**APPLICATION NO. A/NE-TK/837 FOR PERMISSION  
UNDER SECTION 16 OF THE TOWN PLANNING ORDINANCE**

Annex 1 - Response to Comments Table

Section 16 Application for Temporary Public Vehicle Park (Private Cars Only) with Ancillary Electric Vehicle Charging Facilities and Ancillary Solar Panels and Associated Filling of Land for a Period of 3 Years at Lot No. 241 in D.D. 23 at Ting Kok, Tai Po, New Territories

*(Source: HK GEODATA STORE, HKSAR Government)*

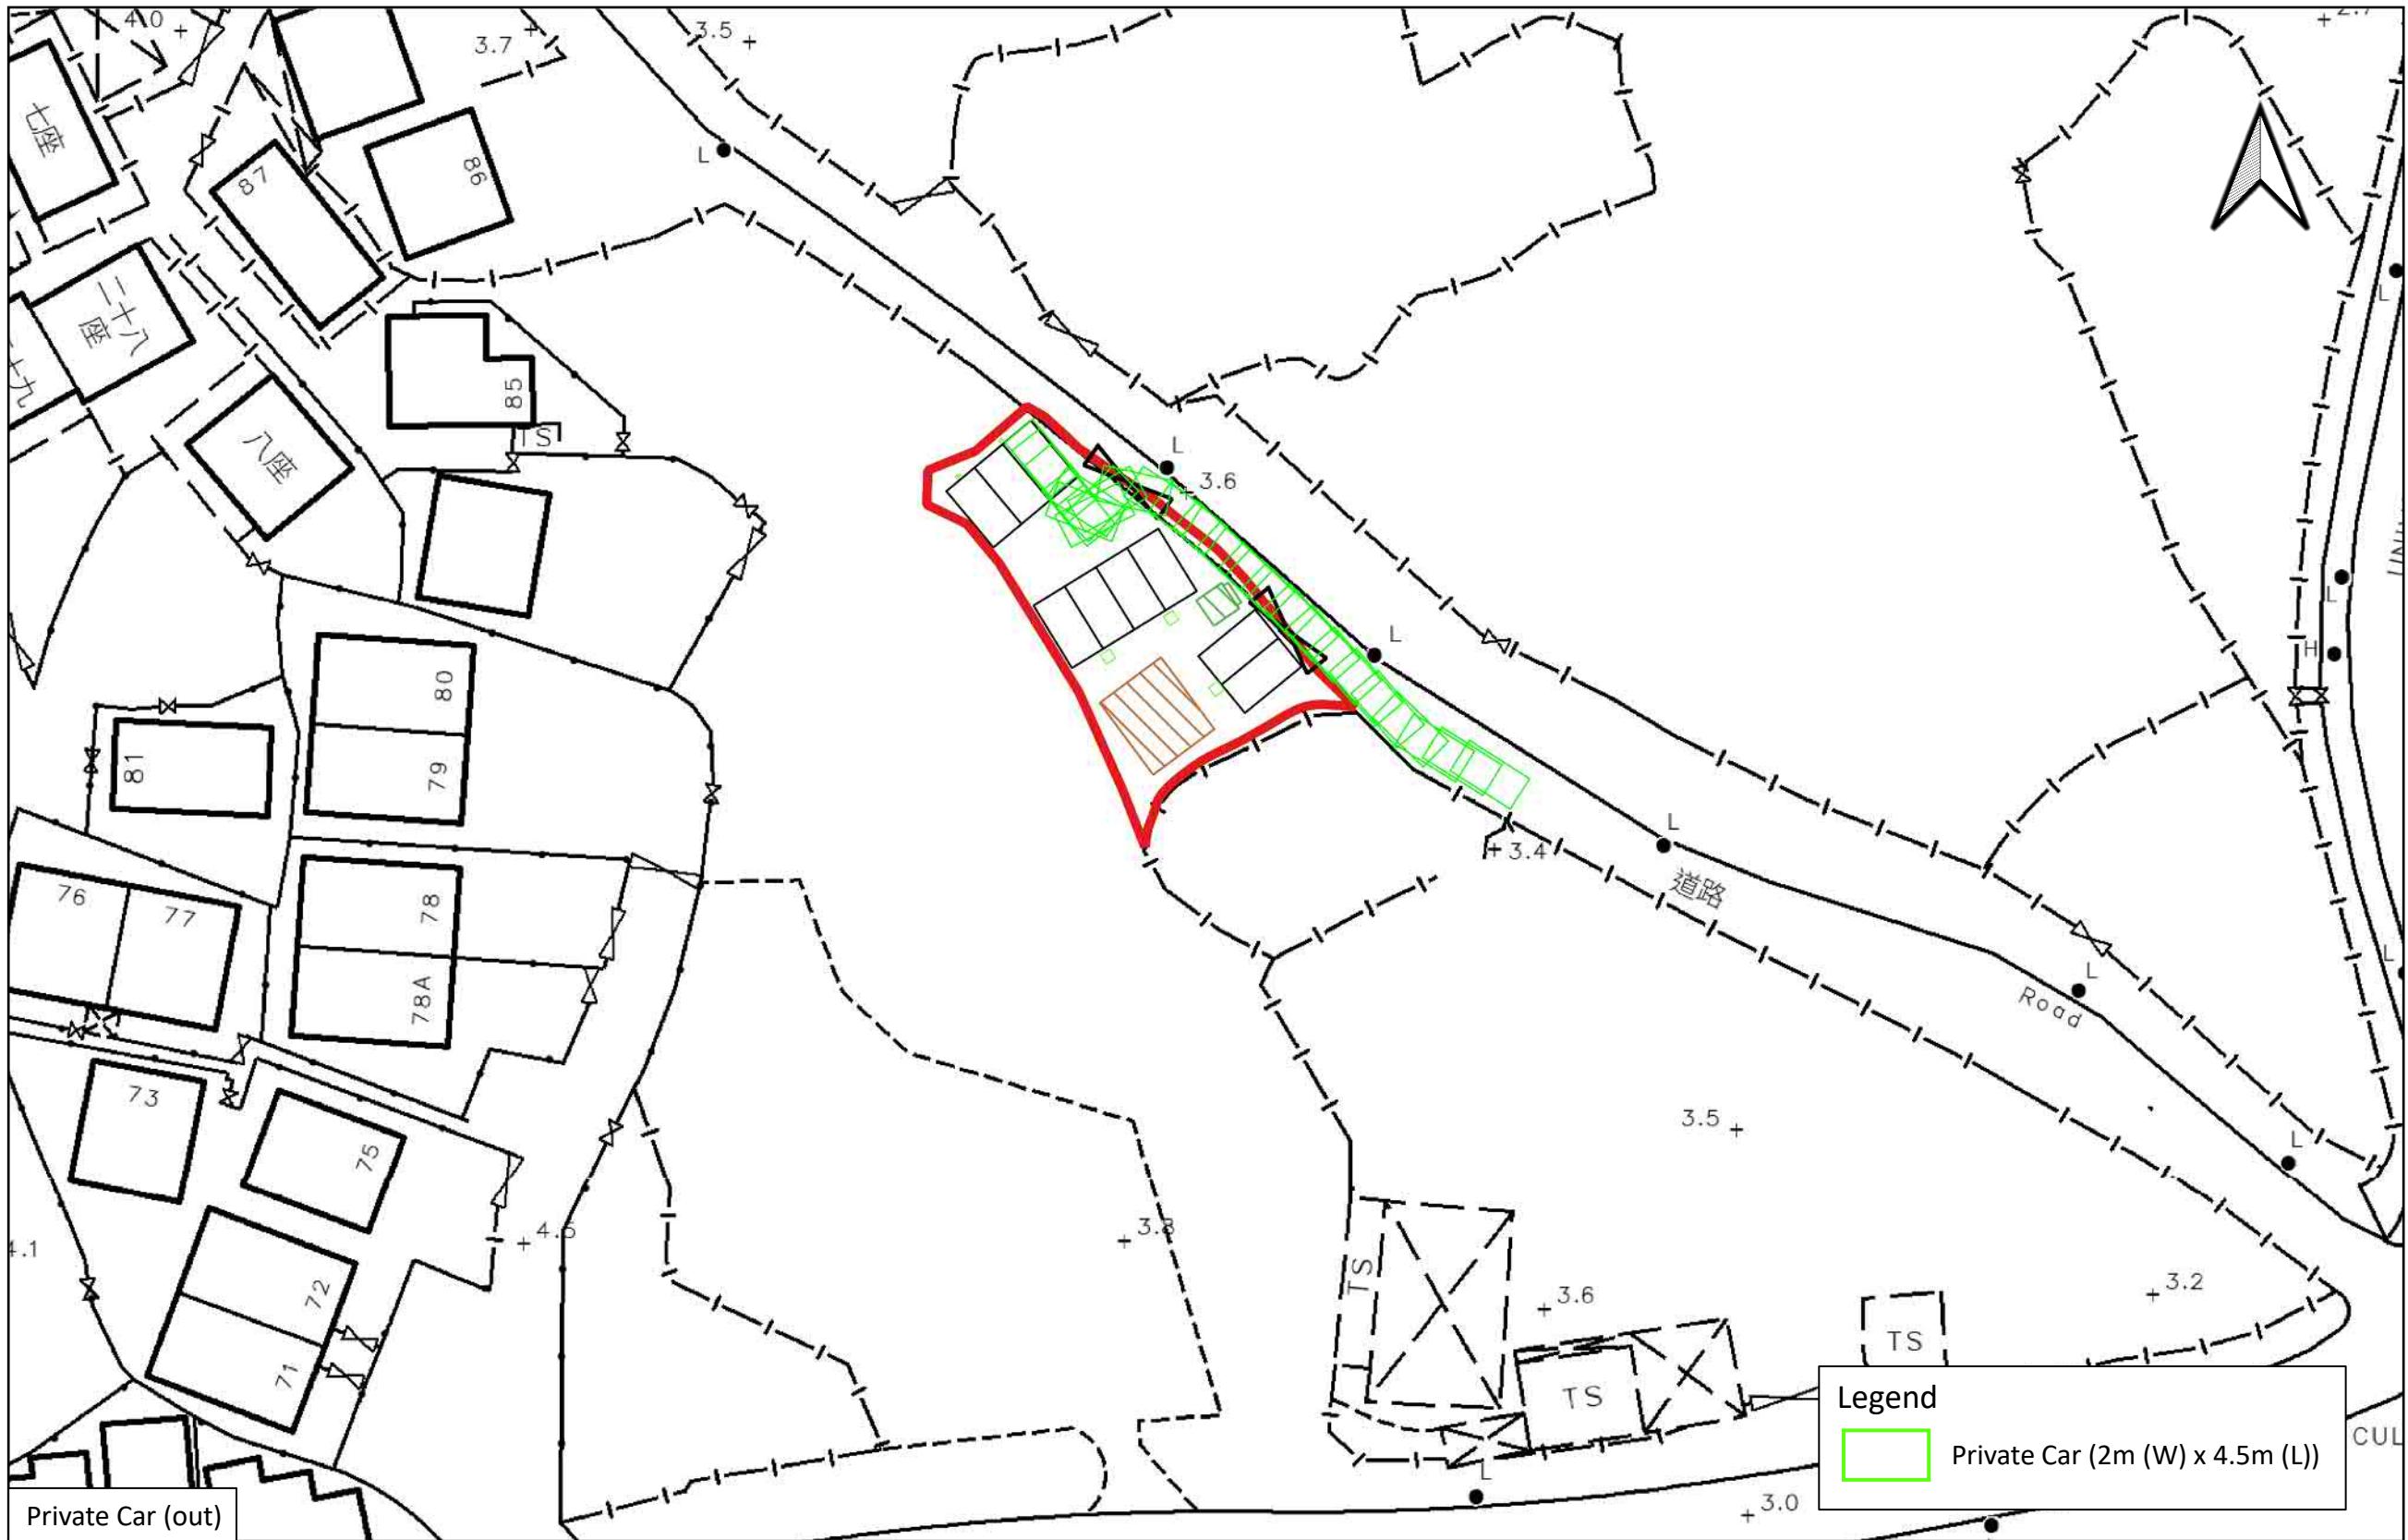
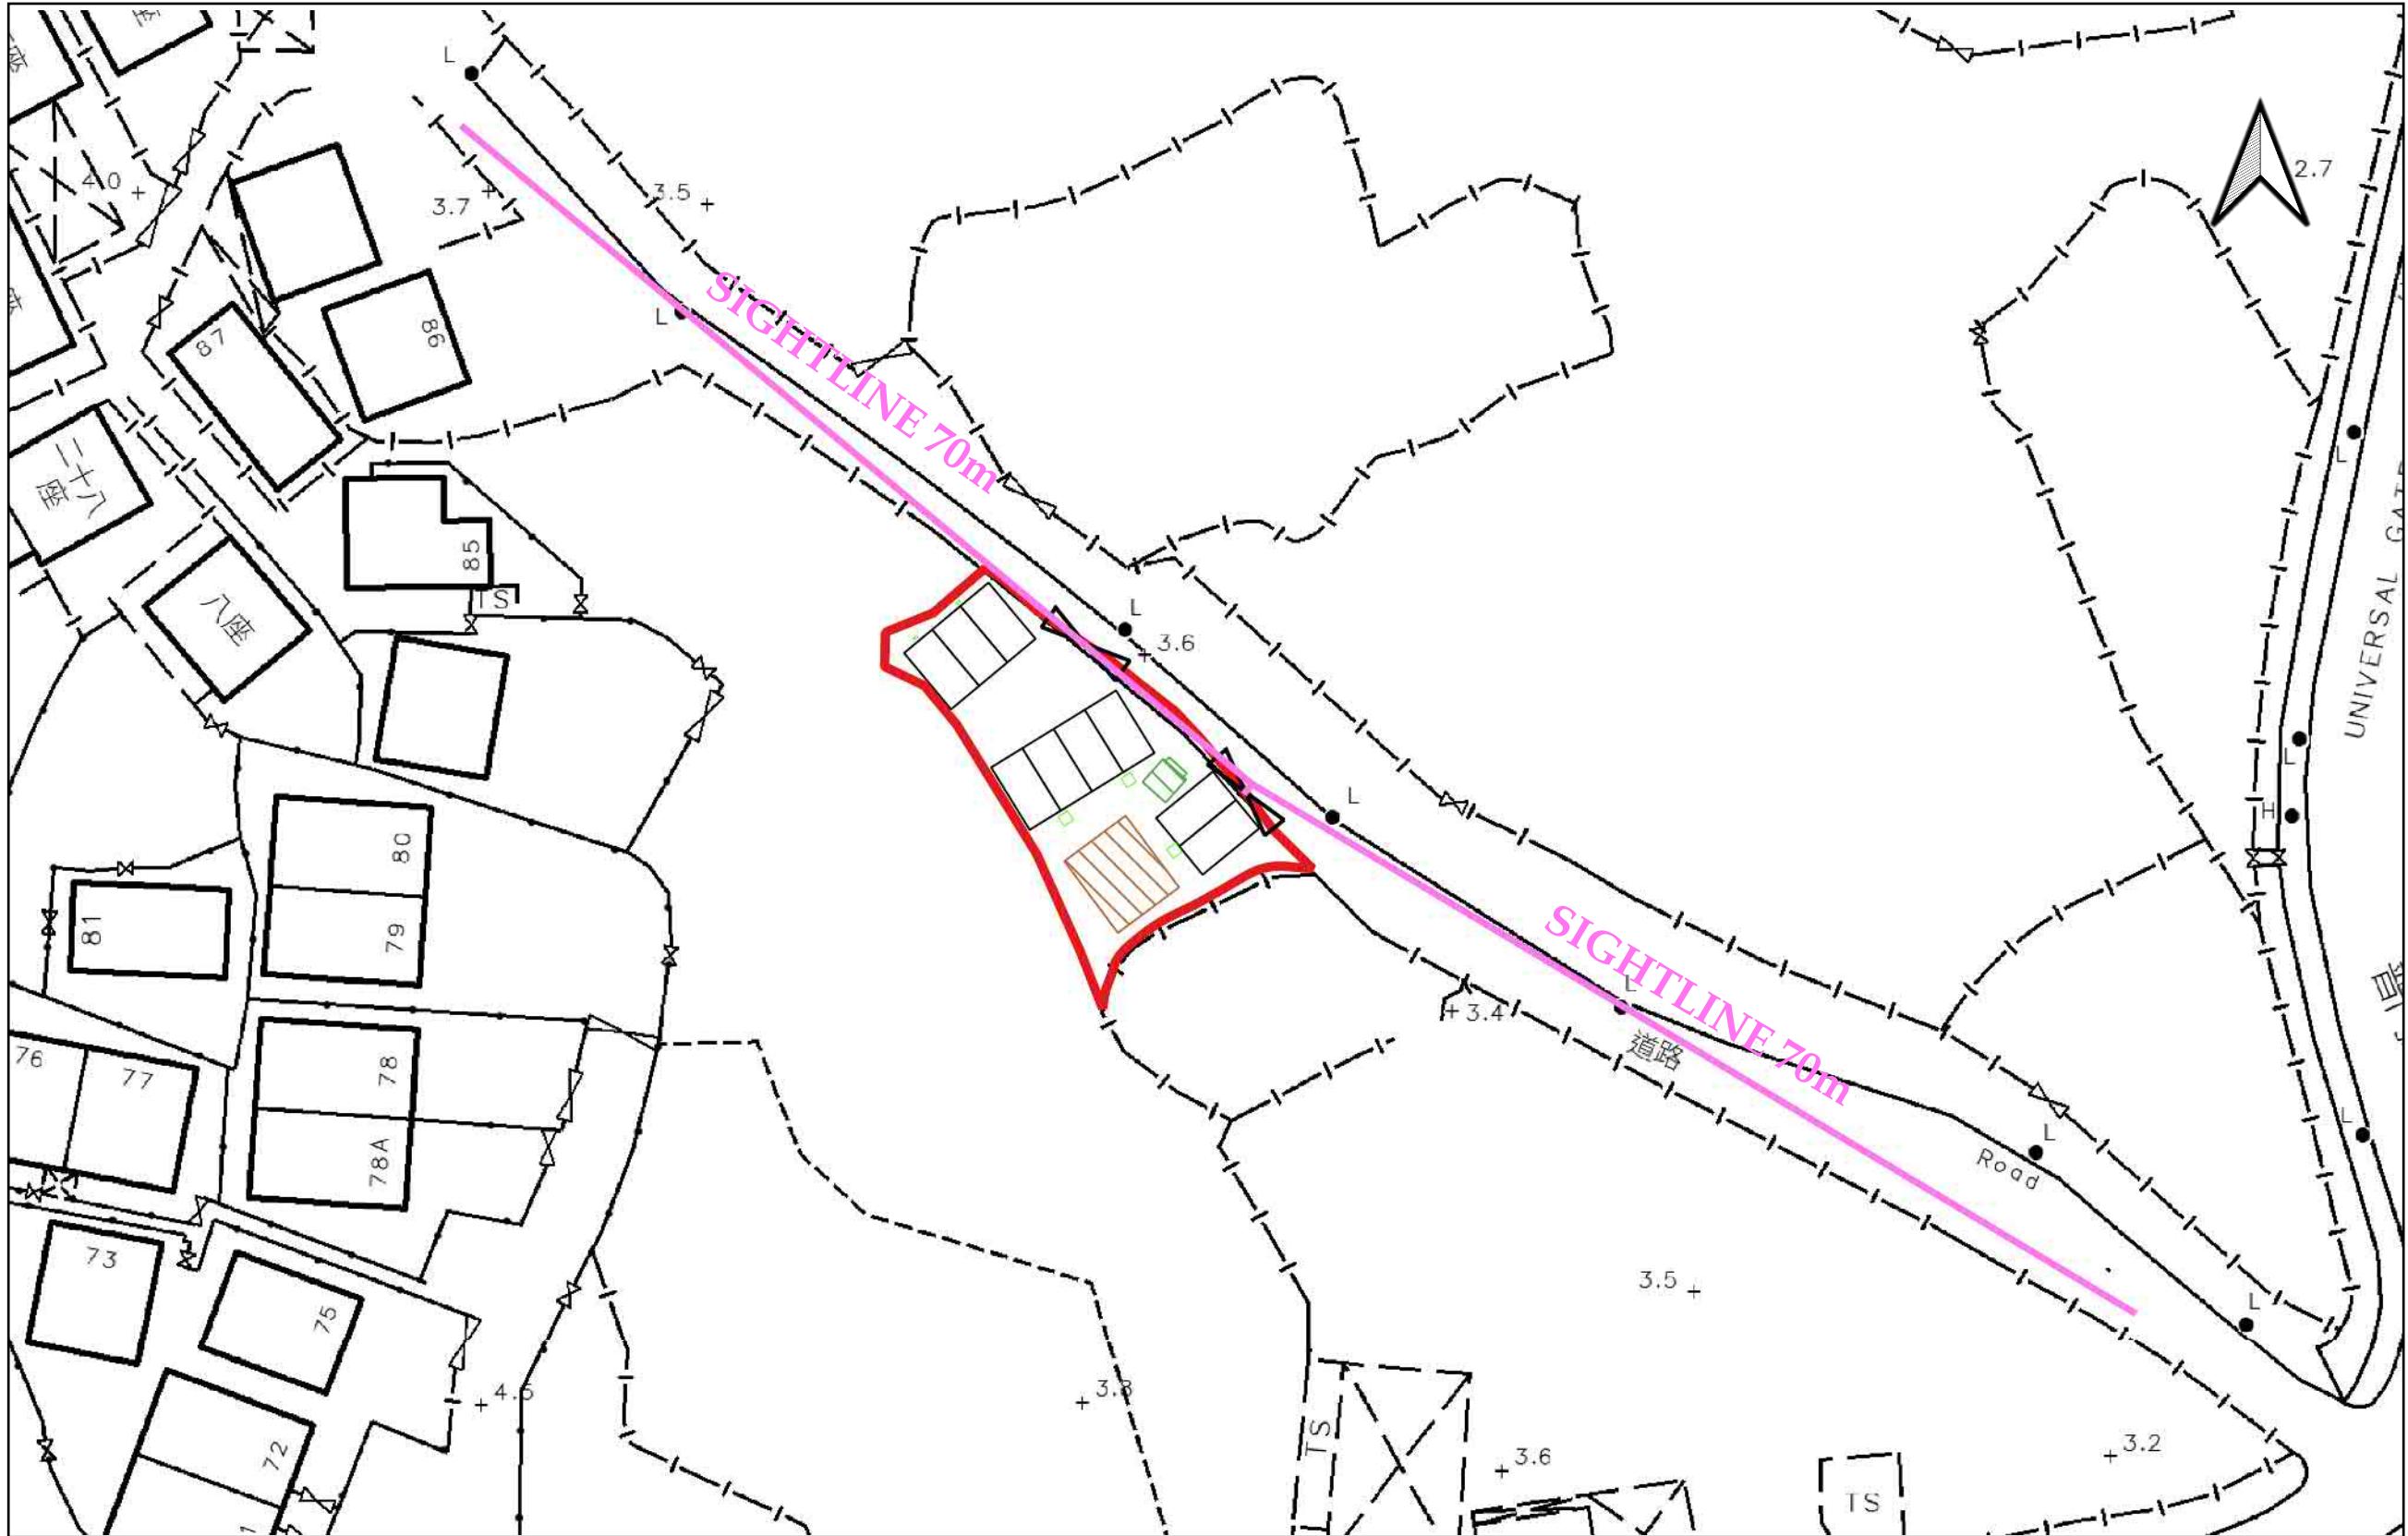
operations of electric taxis and achieve the aforesaid target. In this connection, we recommend that the applicant consider installing some fast chargers with a rated output power of 100kW or higher at the proposed site and open up a certain number of charging spaces for electric commercial vehicles for use, e.g. electric taxis and electric light goods vehicles.	
<b>2</b> <i>Comments from Transport Department received on 22 July 2025</i>		
d	For vehicular access: (i) The number of vehicular access for a development site shall be limited to one from traffic management viewpoint. The applicant shall review the number and location of the vehicular access.	Well noted with thanks.
e	(ii) We note from the swept path analyses that the private car will clash with the existing lamppost. The applicant is reminded to review the locations of access gate and other street furniture to avoid conflicts.	Noted.  The swept path analysis in <b>Annex 4</b> has been revised and it is illustrated that there will be no conflict with street furniture.

f	(iii) The two parking spaces directly in front of the southern access create safety concerns due to limited visibility of drivers and increase risk of accidents when reversing.	Well noted.  It is assumed that vehicles driving out from the Application Site will stop at the southern access and view both sides carefully due to the level difference. Based on the sightline analysis as shown in <b>Annex 5</b> , it is revealed that adequate visibility could still be provided for vehicles both driving in from Tung Tsz Road and driving out from Application Site, and they will not be affected by the Proposed Development and its vehicular access.
g	For the car park layout: (i) The applicant shall demonstrate that there are sufficient spaces for maneuvering of vehicles within the areas, in particular for the parking	Noted.  The swept path analysis in <b>Annex 4</b> has been revised to ensure that there is sufficient space for vehicle to maneuver within the site, particularly for the
